**P802.1Qcz D0.5**  
**2<sup>nd</sup> Task Group Ballot**  
**Editor's Report and Discussion**

Paul Congdon

January 2020

## 98.5.3.1 trInit()

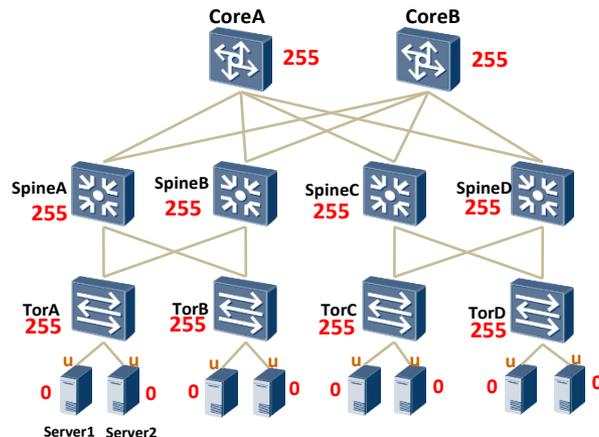
- The trUpdate() algorithm in the current draft has a flaw in it.
- Two independent implementations have found and corrected the issue.
- Details of validation follow

```
if (the receiving device is a server)                                # Servers are always at 0
    return;
if (the sending device doesn't know its level)                      # Sender isn't providing any info
    return;
if (if the sending and receive device are at the same level)      # Crosslink case
    if (receiving port is already a crosslink)
        return;
    else
        set receiving port to crosslink
if (if the sending level is one greater than the receiving level) # Uplink case
    if (receiving port is already an uplink)
        return;
    else
        set receiving port to uplink
if (if the sending level is one less than the receiving level)    # Downlink case
    if (receiving port is already a downlink)
        return;
    else
        set the receiving port to downlink
If (the sending level is less than the receiving level minus 1) OR (the receiving level is unknown)
    set the receiving level to the sending level plus 1           # Works because unknown = -1

set the receiving port to downlink
    set all other ports on the receiving device to unknown
```

Call trSet() for any ports that had something change locally

# Comment 166 - Virtualization

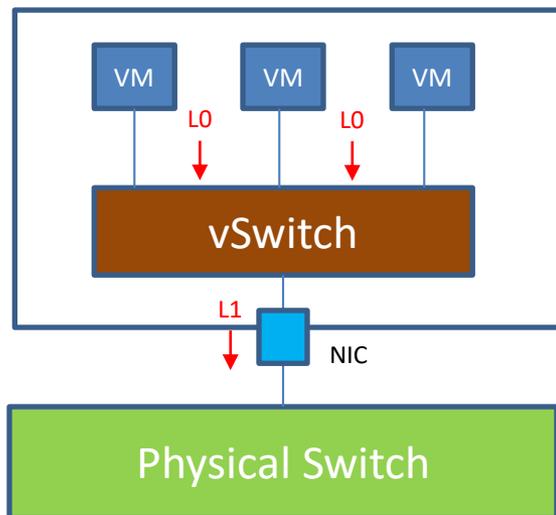
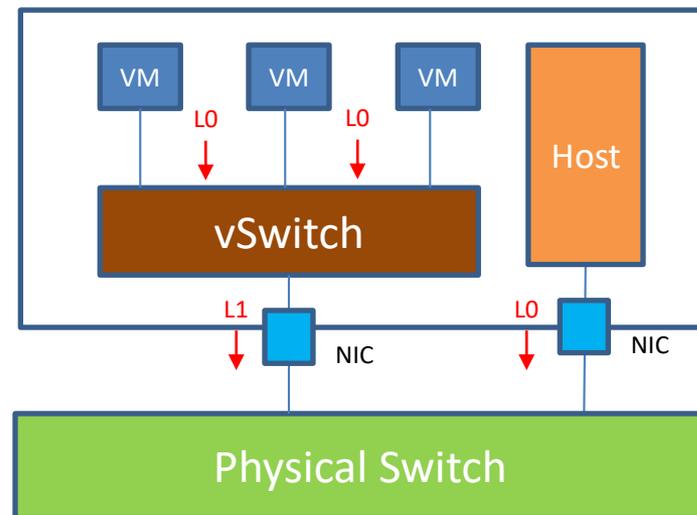
- The term level refers to end systems a level 0. With virtualization technologies end systems may have virtual bridges and levels inside them. These interfaces can be exposed but it is more normal that they are tunneled between servers. However the question arises that if a virtual bridge interface is enabled and LLDP is turned on a) would this impact topology recognition? Also would there be vulnerability to an implementation that spoofed
